DPO Case File for DPO-2013-002

The following pdf represents a collection of documents associated with the submittal and disposition of a differing professional opinion (DPO) from an NRC employee involving seismic issues at Diablo Canyon.

Differing Professional Opinion – Diablo Canyon Seismic Issues

Figure 1, Comparison of the DDE/SSE and the HE Floor Response Spectrum, Containment Elevation 88'

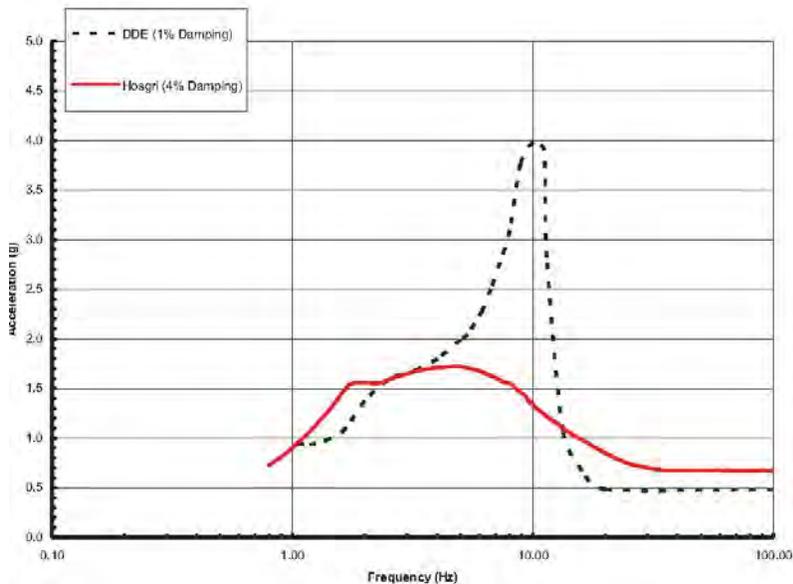
Figure 1 illustrates the results of the different methods and assumptions use in DDE/SSE safety analysis and the HE. This figure compares acceleration levels (shaking) in the reactor containment building.

Note that the level of "shaking" is significantly greater for the SSE/DDE than for the HE at this plant location. This may seem counterintuitive since the HE is a much larger earthquake. However, as this figure illustrates, comparing ground motion alone is not sufficient to evaluate seismic qualification. Methods, assumptions, initial conditions, and acceptance criteria used in the analyses are just as important as ground motion.

The qualification process used information, such as shown in Figure 1, to establish the amount of seismic stress SSCs may be exposed to during the SSE. A component located at this location would be qualified for the SSE/DDE. If the SSC was also credited for HE safe shutdown, no additional qualification would be required. At this plant location, the seismic stress is dominated by the SSE/DDE. Qualification to the SSE/DDE would envelope the seismic stress generated by the HE.

Figure 3
SSE/DDE Maximum CRDM Bending Moments¹⁸

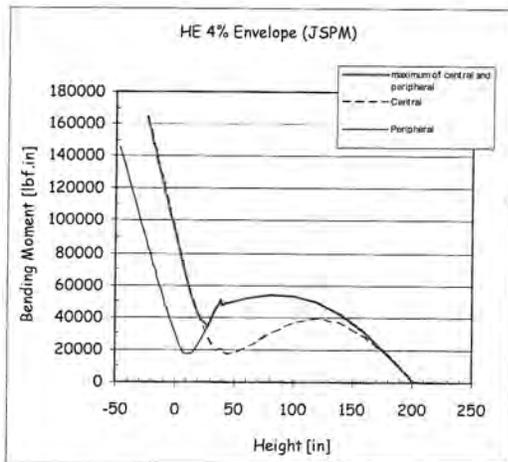
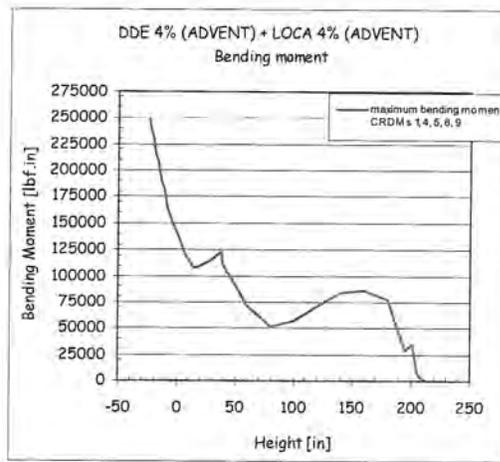
The Code methodology adds seismic loading, generated by either the SSE/DDE safety analysis or the HE, to other non-seismic loads affecting the component. The resulting SSE/DDE stress is significantly greater than for the HE in many loading cases. Again, this may sound counterintuitive since the HE is based on a much larger earthquake. These differences in component stress reflect the differences in the methods, assumptions, load combinations, and initial conditions used in each seismic analysis. For example, Figures 2 and 3 compare the Code bending moments calculated for the control rod drive mechanisms used to support the replacement reactor head modification. As seen in these figures, the bending moments (seismic stress) were much greater for SSE/DDE case than for the HE.

Figure 4
Comparison of the DDE/SSE and the HE Floor
Response Spectrum, Containment Elevation 88'

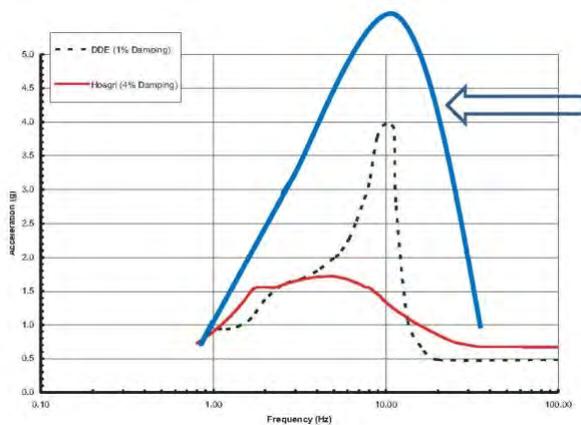
A comparison of the new seismic information against the existing SSE/DDE safety analysis would yield seismic stress greater than the values used during the original SSC qualification. However, in many cases, the actual SSC qualification tests were performed at higher levels than required to meet the design basis. These higher qualification levels provide engineering margin that may be recovered for “operability.”

Figure 2. Response spectra for Diablo Canyon NPP containment building and other structures, from FSARU figures indicated in legend.

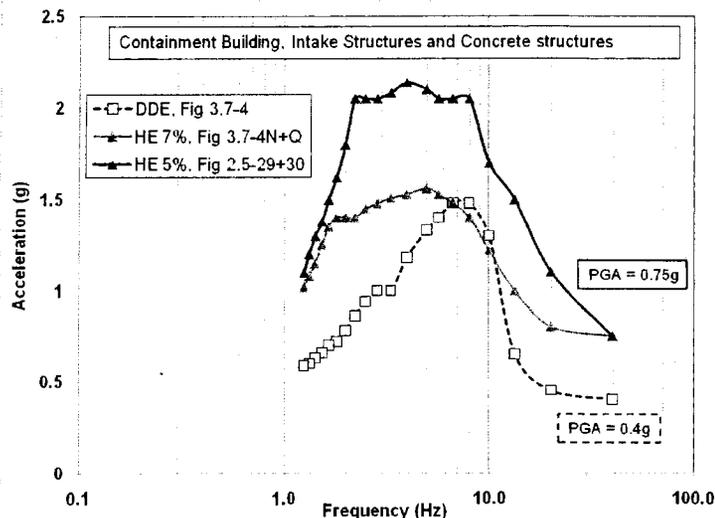
Figure 2 illustrates the importance of these differences in analytical methods and assumptions. Analyses of seismic loads on the Diablo Canyon containment building used 5% damped, *free-field* ground motions for the DDE. However, the HE analyses used 7% damped, *foundation-filtered* ground motions, which are approximately 10% lower than the DDE ground motions for 7–10 Hz frequencies. Load calculations on the containment building are sensitive to this frequency range. Consequently, these different methods and assumptions result in the DDE creating higher calculated loads on the containment building than the HE. For some other important structures, systems, and

discussed in the background information (see Figure 2), some SSC analyses used ground motions for the Hosgri evaluation that were effectively lower than DDE ground motions. This situation occurs because most safety analyses were done with ground motions that were different than the 5% damped free-field reference condition.

Returning to the containment building example from Figure 2, seismic loads for the Hosgri evaluation were represented by a 7% damped, foundation-filtered ground motion. In contrast, DDE seismic loads in these analyses were calculated with a 5% damped, free-field ground

motion. Thus, the DDE created the highest accelerations (i.e., structural loads) at spectral frequencies of 7 to 11 Hz. If these DDE and HE ground motions were inappropriately compared to the new ground motions shown in the 2011 Shoreline report (Figure 4), it would appear that the new ground motions might exceed the levels previously considered in the FSARU for frequencies of 5 to 30 Hz. Nevertheless, the assumed validity of this incorrect comparison is a fundamental assumption for the logic in the DPO submittal regarding the need for additional actions by both PG&E and NRC.

Figure 3 Ground motions from indicated figures in FSARU (DDE, HE), Long-term seismic program (LTSP), and 2011 PG&E Shoreline report (ergodic method).

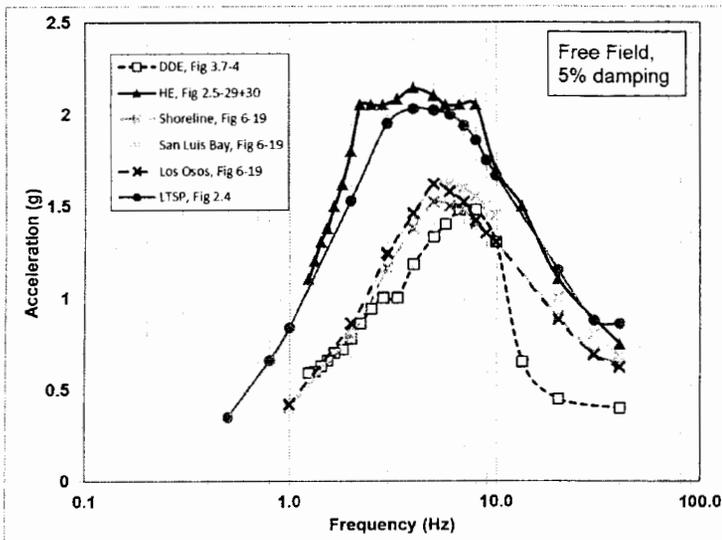
For this concern, the Panel determined that the evaluations to-date may not have fully considered the potential significance of the new ground motions on the existing FSARU licensing basis for Diablo Canyon. The DPO submitter identifies some shortcomings in previous evaluations, but also makes incorrect comparisons between the new information and information in the FSARU to reach a conclusion about operability and appropriate licensee and NRC actions. The incorrect comparisons appeared to have occurred, however, because PG&E provided insufficient information in the 2011 Shoreline report to appropriately compare the new ground motions to the range of ground motions actually used in the seismic analyses described in the FSARU. Thus, additional information was needed by NRC, PG&E, and the DPO submitter to make correct comparisons.

In the 2011 Shoreline report, PG&E develops new ground motions for the Shoreline, Hosgri, San Luis Bay, and Los Osos faults and compares these ground motions to the original Hosgri evaluation and the Long-Term Seismic Program. This comparison only evaluates results for a standard reference condition, which is a free-field ground motion with 5% damping (Figure 3). As shown in Figure 3, if the original Hosgri evaluation represented the largest ground motions actually considered in the design and qualification of SSCs, then the newer ground motions would clearly be lower than already considered in the original FSARU licensing basis. However, as

The remainder of this DPO concern focuses on the same issue of ground-motion comparability that was discussed for DPO Concern #1. As shown in Figure 3, potential ground motions for the Los Osos and San Luis Bay faults can be approximately 10% higher than potential ground motions for the Shoreline fault. Ground motions for these three faults were all calculated with the same methods and assumptions. Thus, equivalent changes in the amount of damping or presence of building foundations should have equivalent changes in the calculated ground motions. In other words, the relative relationships between these three ground motion response spectra should not change significantly. Nevertheless, the Los Osos and San Luis Bay potential ground motions shown in Figure 3 have the same limitation as the Shoreline potential ground motions, in that they are not directly comparable to the full range of ground motions used in the FSARU to license Diablo Canyon. As discussed in Concern #1, these faults were considered explicitly in the March 2014 supplemental analyses by PG&E. The reanalyzed ground motions for the Los Osos and San Luis Bay (and the Shoreline) faults do not exceed the level of ground motion already used to design and license the plant.

Figure 4. Ground motions from FSARU and 2011 Shoreline Report figures (ergodic method), incorrectly assuming the new ground motions are directly comparable to FSARU inputs for containment building analyses.

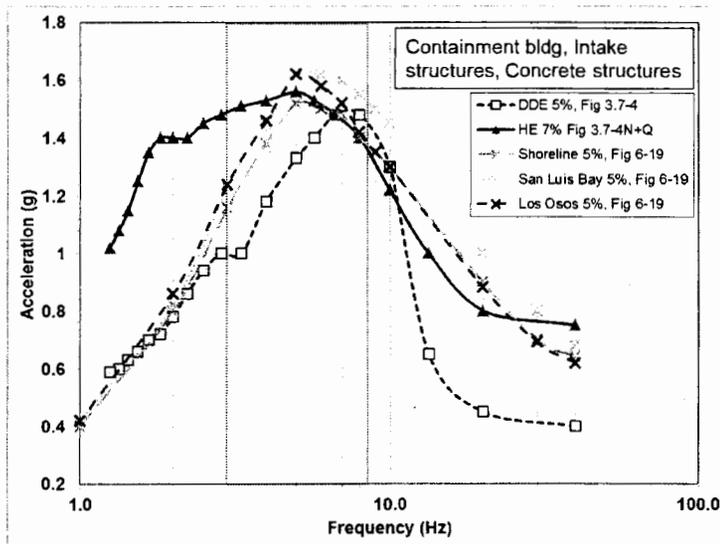
During the review of the DPO submittal, the Panel determined that this type of comparison incorrectly assumes the 5% damped free-field ground motions appropriately represent potential ground motions from the Shoreline, Los Osos, and San Luis Bay faults. In order to make an appropriate comparison to the ground motions used to design and license the plant, additional information was needed from PG&E. This information would need to consider if other levels of damping should be used for the new ground motions, such as those corresponding to a Safe Shutdown Earthquake in Regulatory Guide 1.61. PG&E also would need to consider if other potentially significant effects,
